Axiom Hub

Version: V1.0.5

Release Note

(2019-11-01)

2) Add Duress Code function:

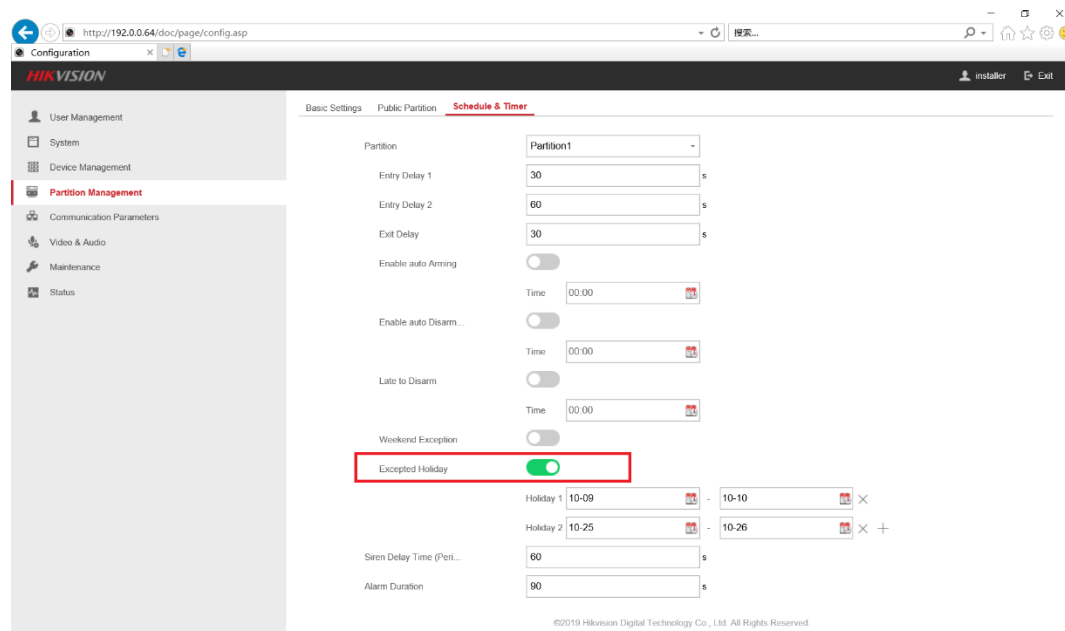
The keypad password +1 or -1 is Duress Code. Use the duress code can operate the keyboard to arm and disarm normally and upload a duress alarm. For example, if the keypad password is 123456, the duress code is 123455 or 123457.

5) Add Excepted Holiday function:

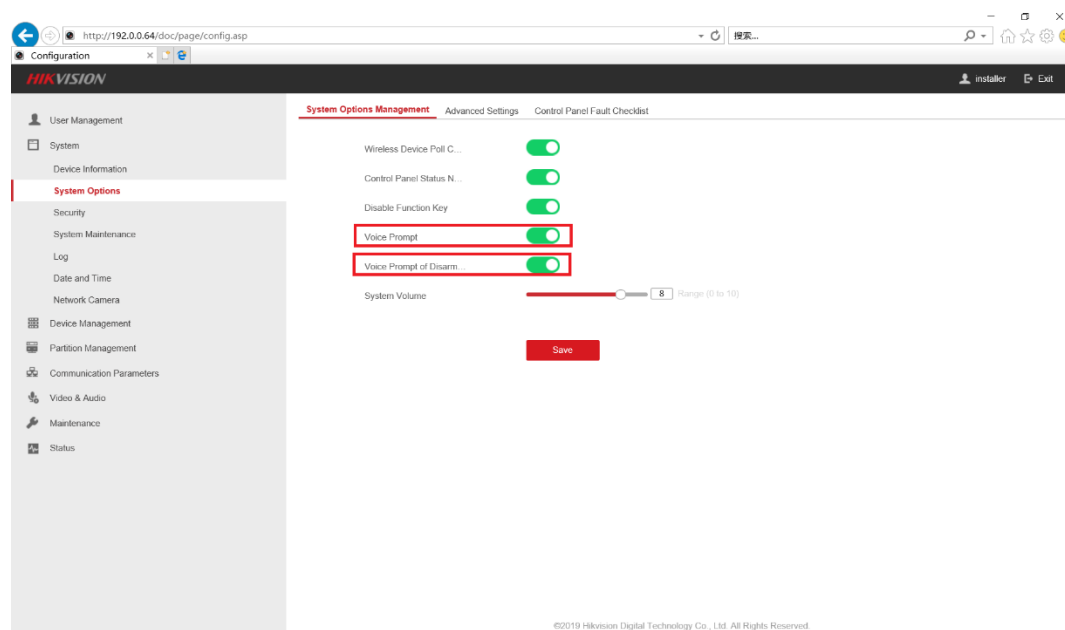
Enable the function and the zone will not be armed/disarmed in the holiday. Up to 6 holiday groups can be set.

8) Added 4200 remote configuration function.

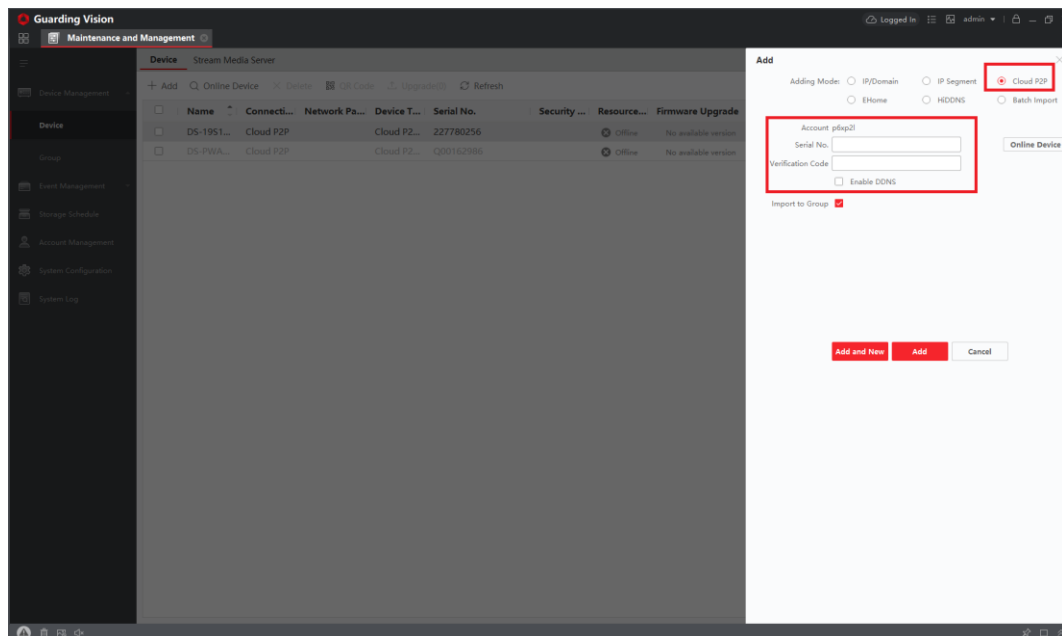
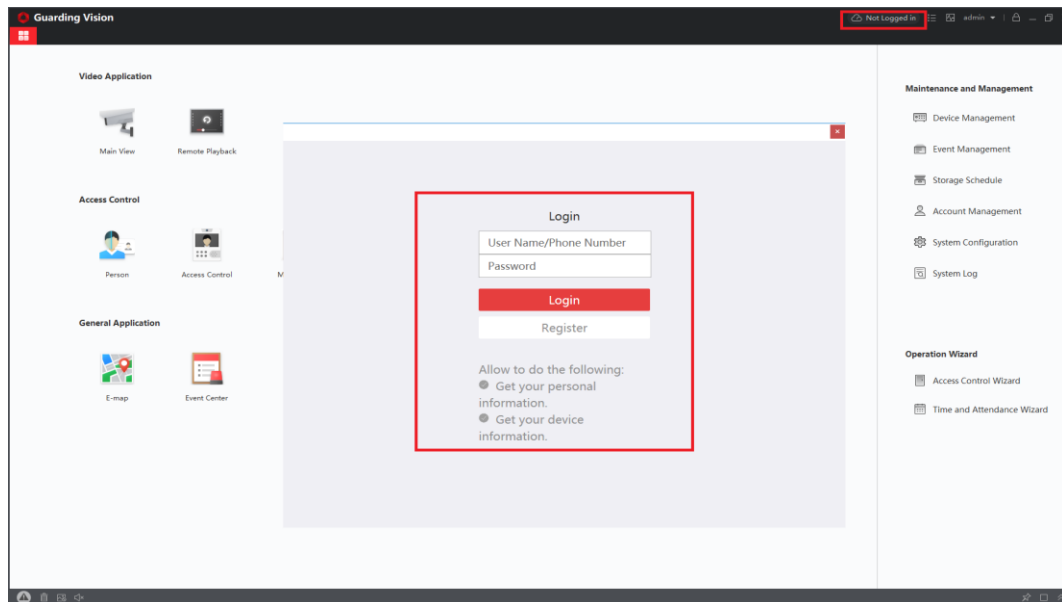
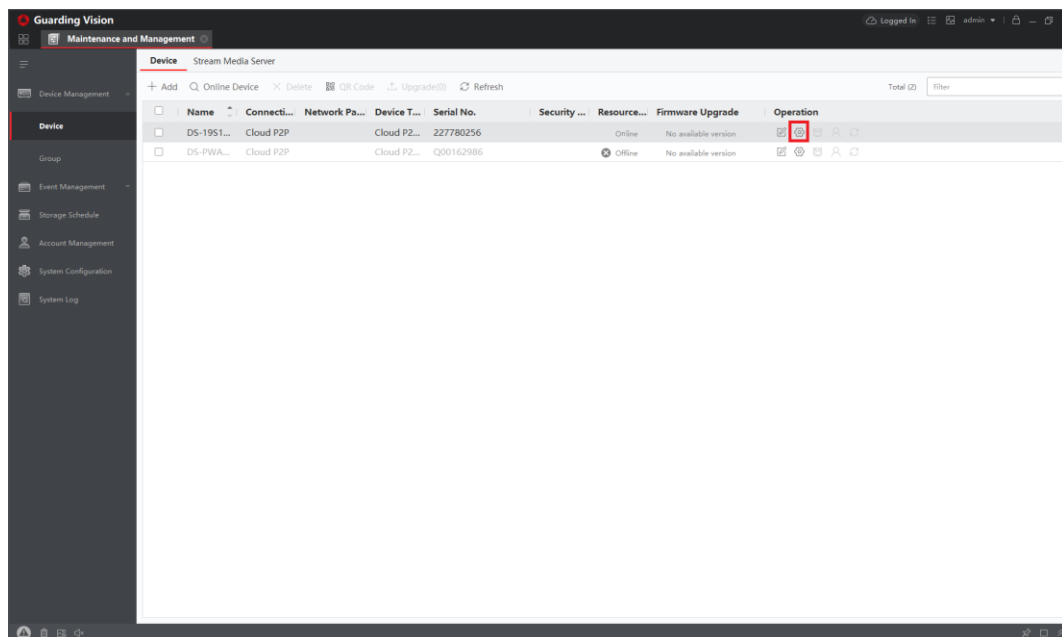
The installer can login Hik-connect account through the 4200 client, and then add the device to the account. Then they can click the Remote Configuration button to configure it.

1) Wireless Siren Number Optimization:

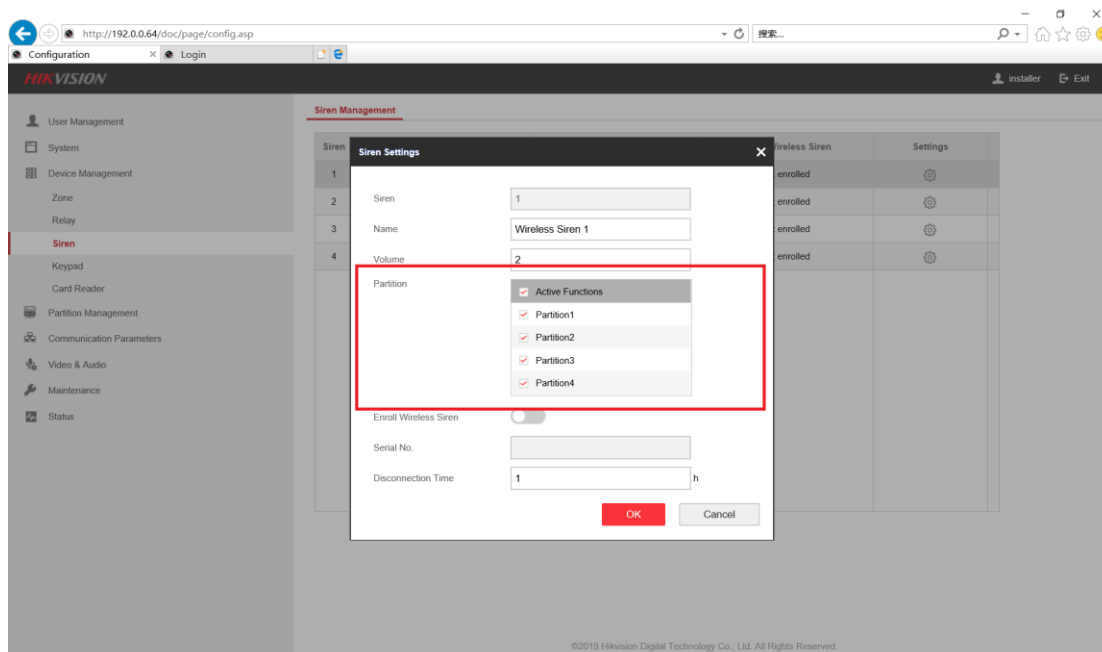
Change the number of wireless siren from 2 to 4, and then siren now can link to Partition. Panel or wireless output module tamper can trigger all wireless siren alarm. Wireless siren, wireless card reader, wireless keypad or wireless detector tamper can trigger partition corresponding siren alarm. When the zone alarm, only partition associated siren will alarm.

2) Swipe Card Arm/Disarm Function Optimization:

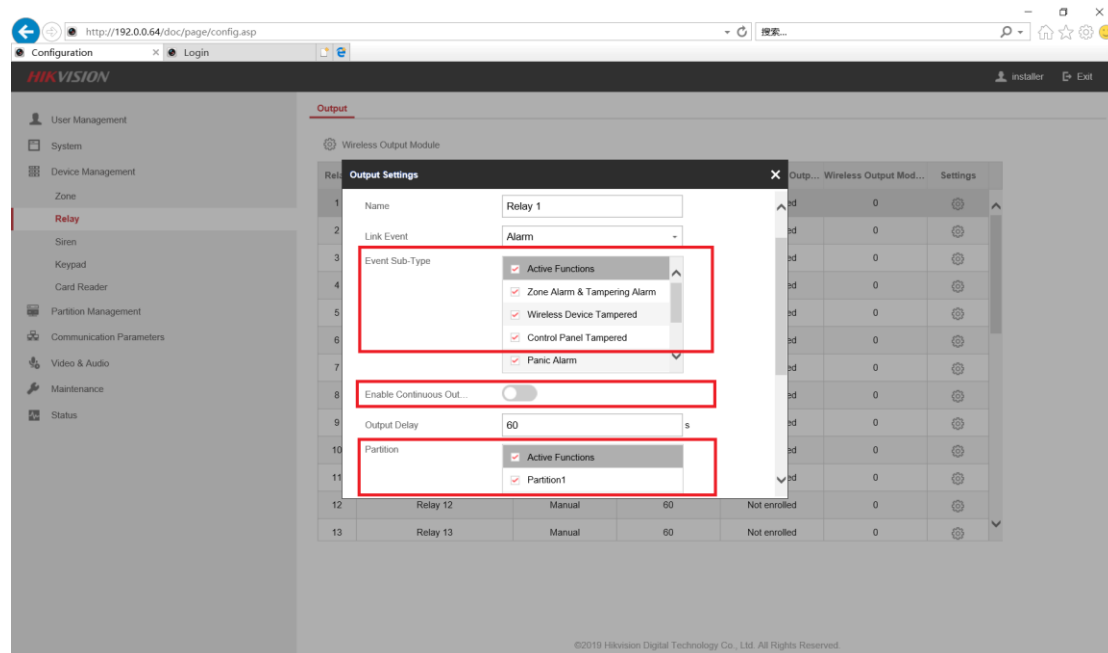
When the Panel is in disarmed status and there is no alarm, the sound of the card-swiping sound is less than or equal to 5 times, it means **Away Arm**. If the number of

times the card-swiping sound is greater than 5 times, means **Stay Arm**;

If Panel have system fault, and you swiping the card twice in disarm status, The Panel will broadcasts System failure prompt.

5) User Function Optimization:

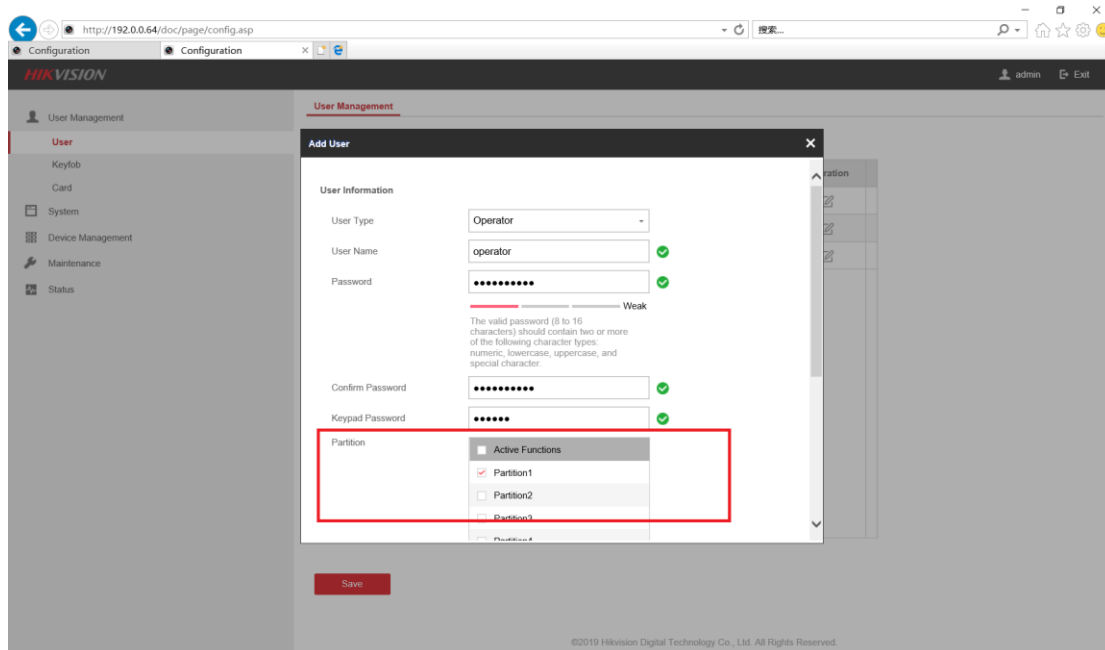
Support the Different User linkage to different Partition.

6) Voice Prompt Optimization:

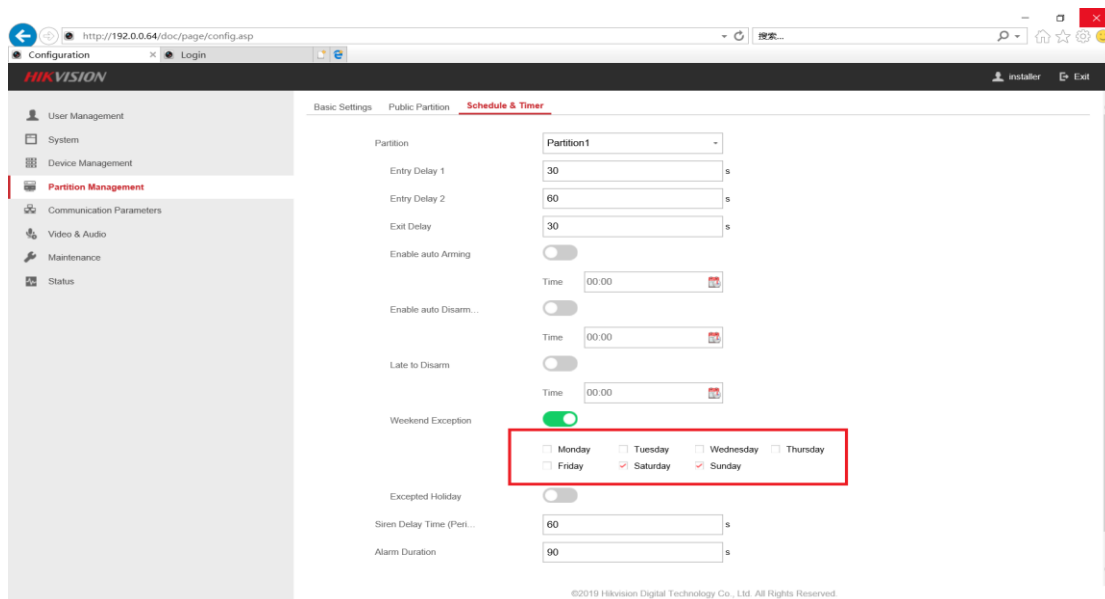
After the tamper alarm of the Panel or peripheral is triggered, the voice broadcasts time duration depend on the Sunder time. When the tamper is restored, the voice broadcast stops,

After the tamper alarm of the Panel or peripheral is triggered, the voice broadcasts time duration depend on the Sunder time. When the tamper is restored, the voice broadcast will continue to broadcast until the end of time.

8) Mobile phone alarm reporting function Optimization:

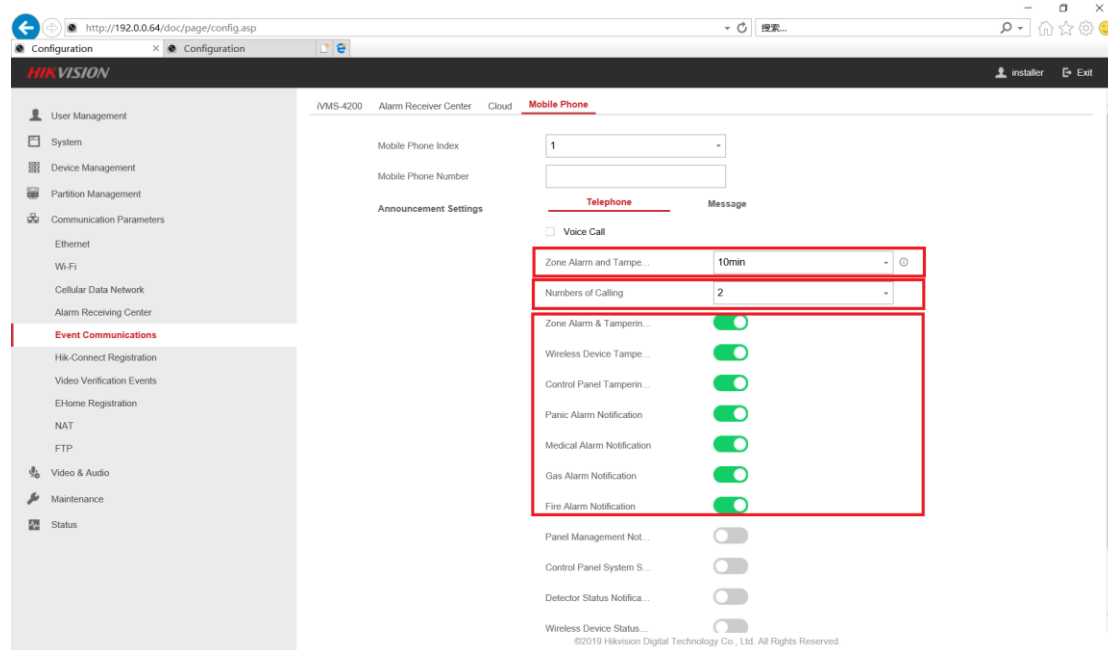
Support zone alarm and Tampering Alarm Filtering time configuration, support number of calling time configuration, event classification redefinition. In addition, add new log for alarm calling report upload success or failure records.
